Sandia National Laboratories

April 9, 1985

Enclosed is the summary of activities during March 1985 for the following tasks (A-1165): (I) Assisting in the Development of the Licensing Assessment Methodology (II) Monitor and Review Aspects of DOE programs; (III) Identifying Techniques for Probability Assignments; and (IV) Short Term Technical Assistance.

SUBJECT: Review of the NRC comments on the hydrology section of the BWIP EA.

LHS Analysis without correlations

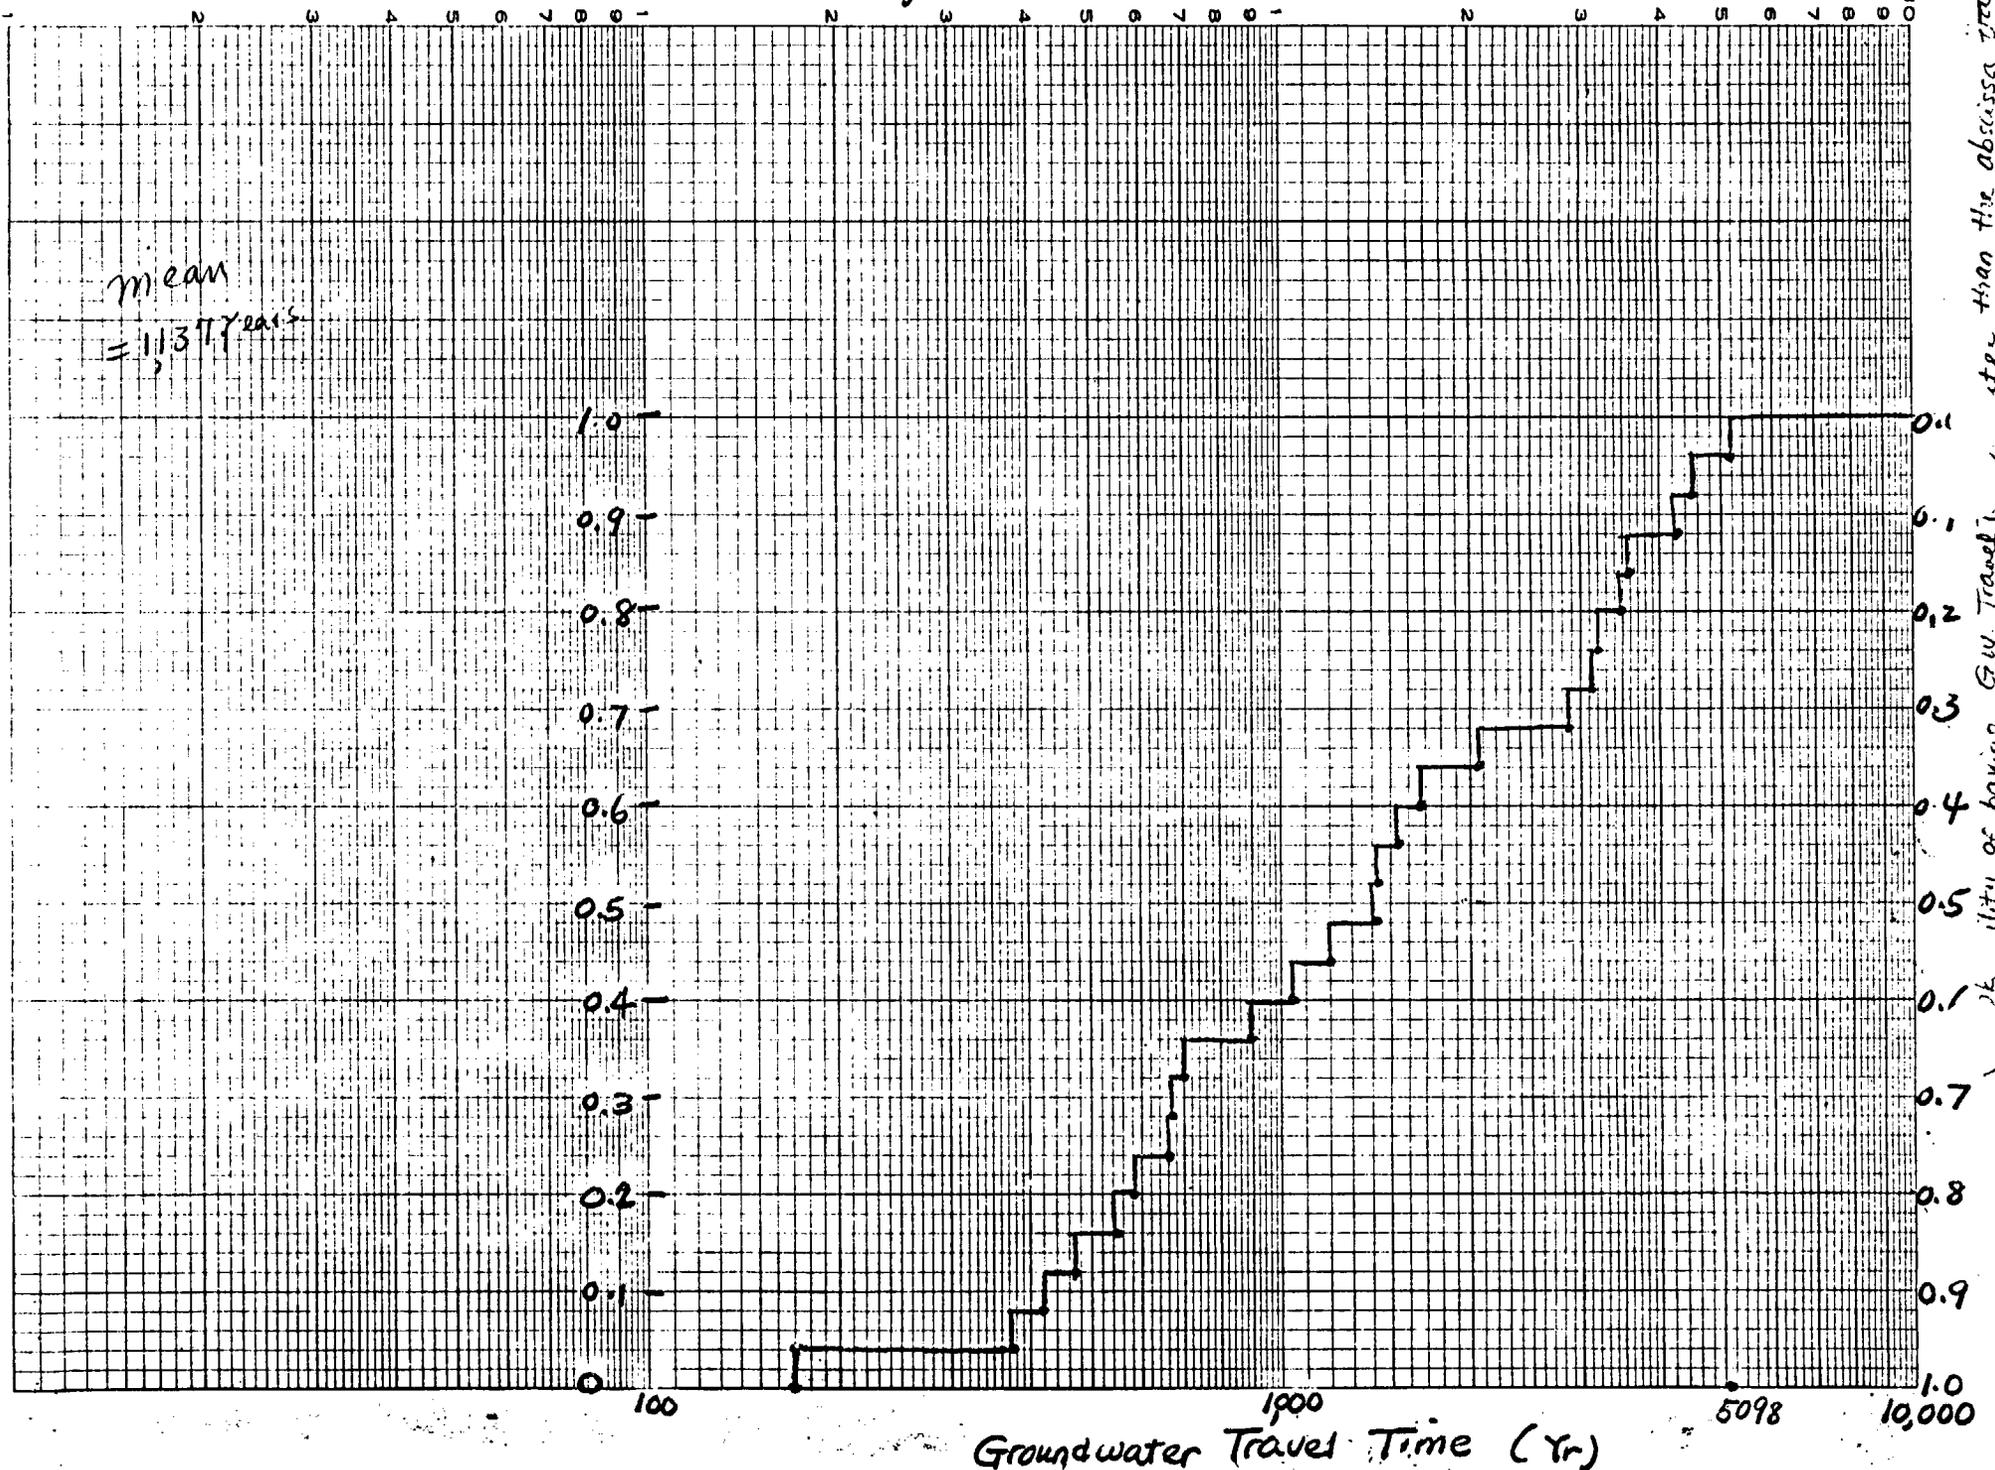
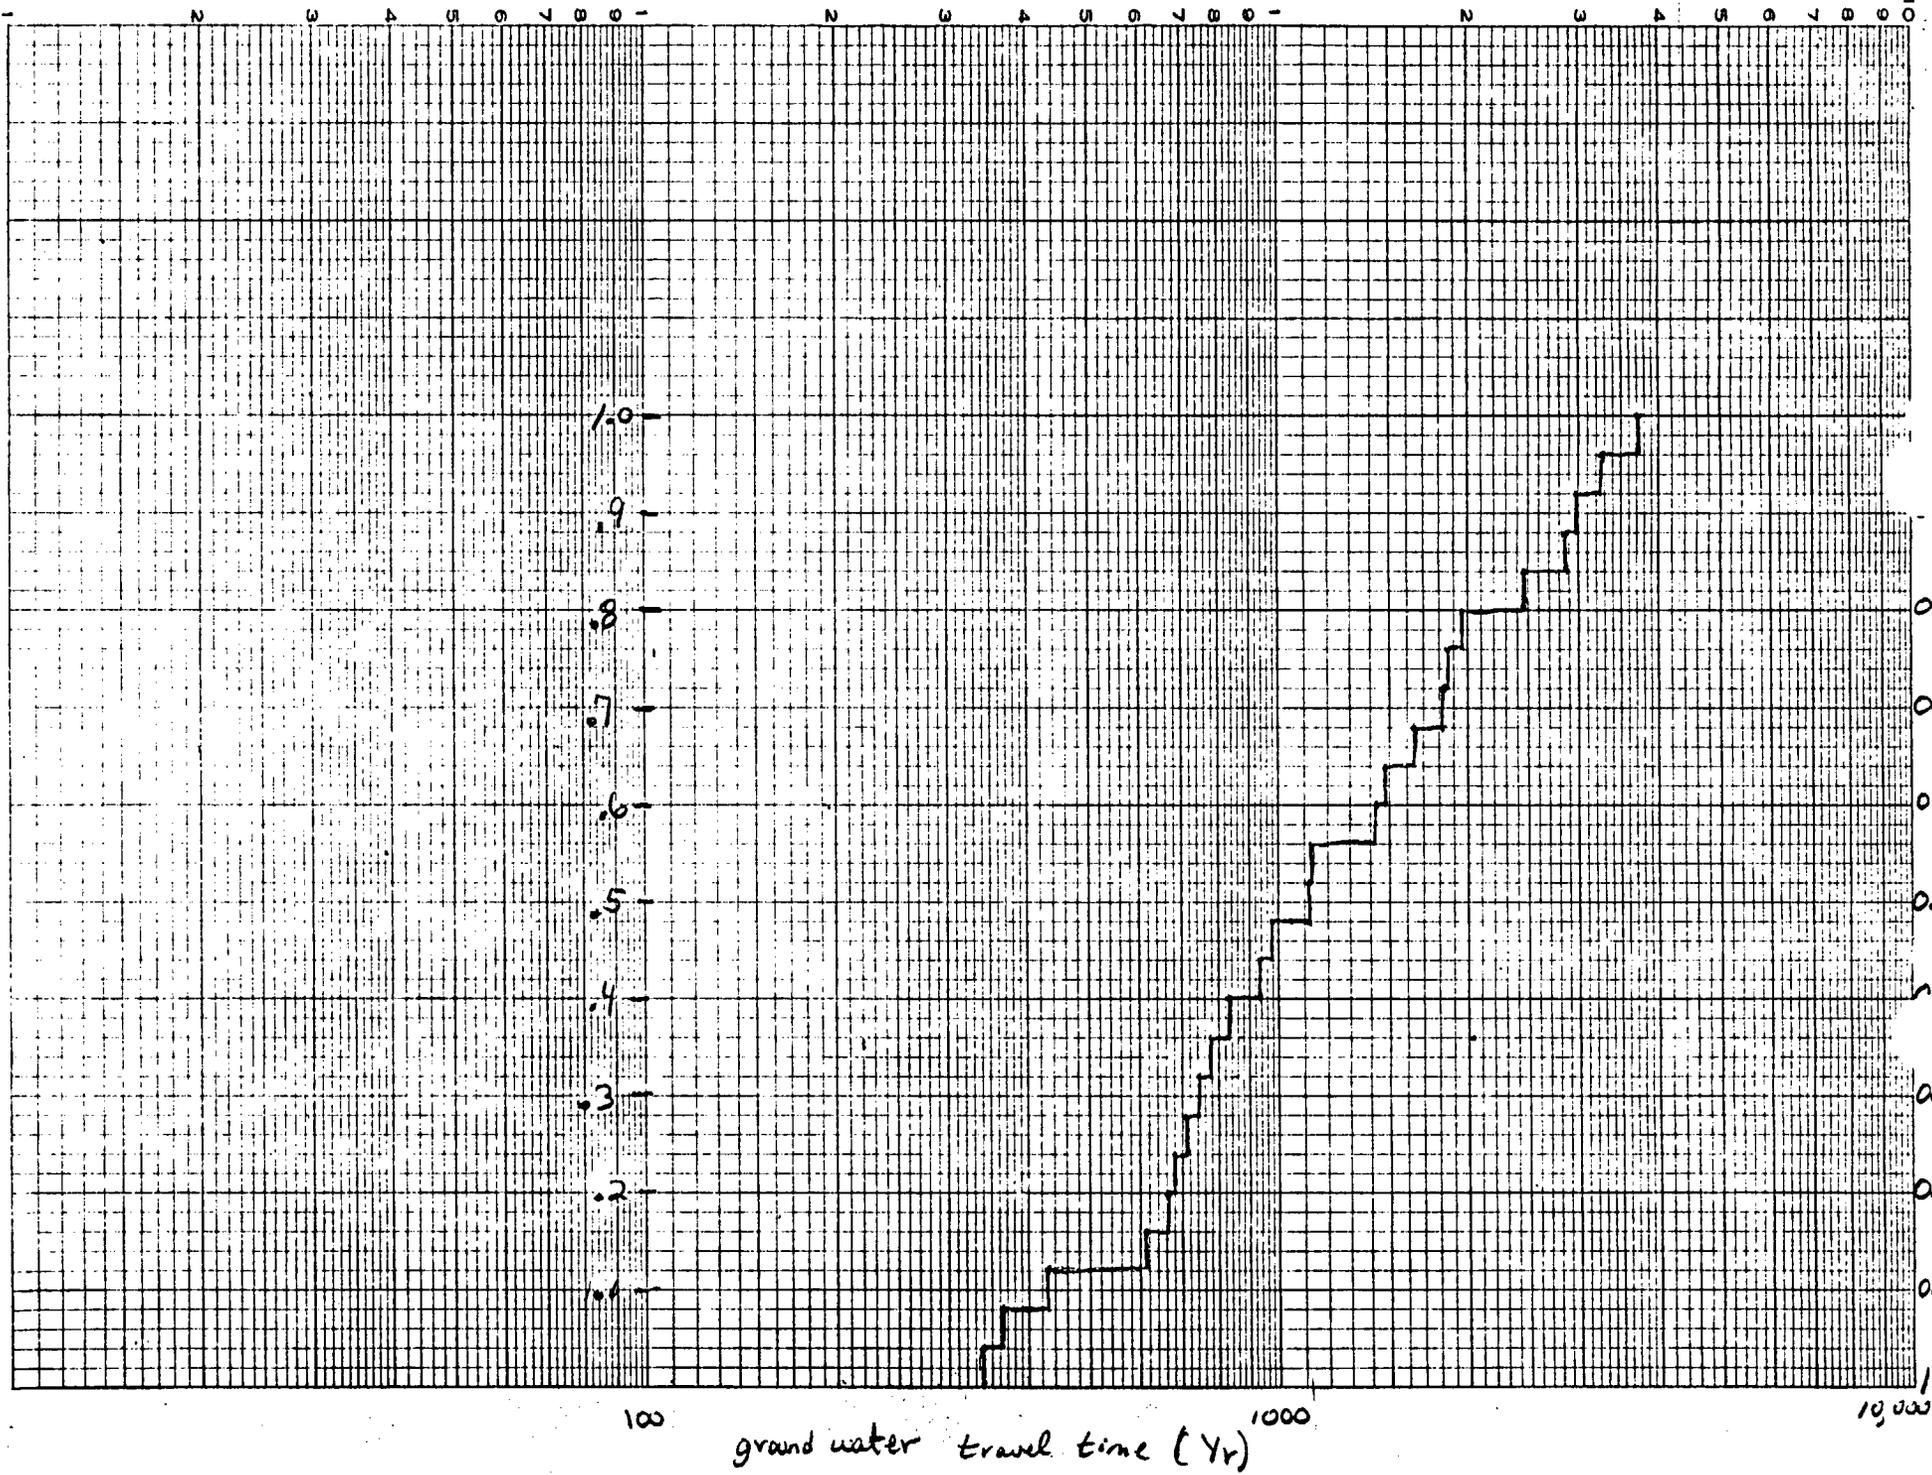
In another light, we performed an independent check of your travel-time analysis. This was done by utilizing your ranges and assumed distributions in Latin Hypercube Sampling and then performing a simple calculation of the travel time. Calculations were performed with and without your assumed correlations. The results are presented in the form of probability distributions and are included herein. Considering the small sample size of 25, these results basically agree with your calculations.
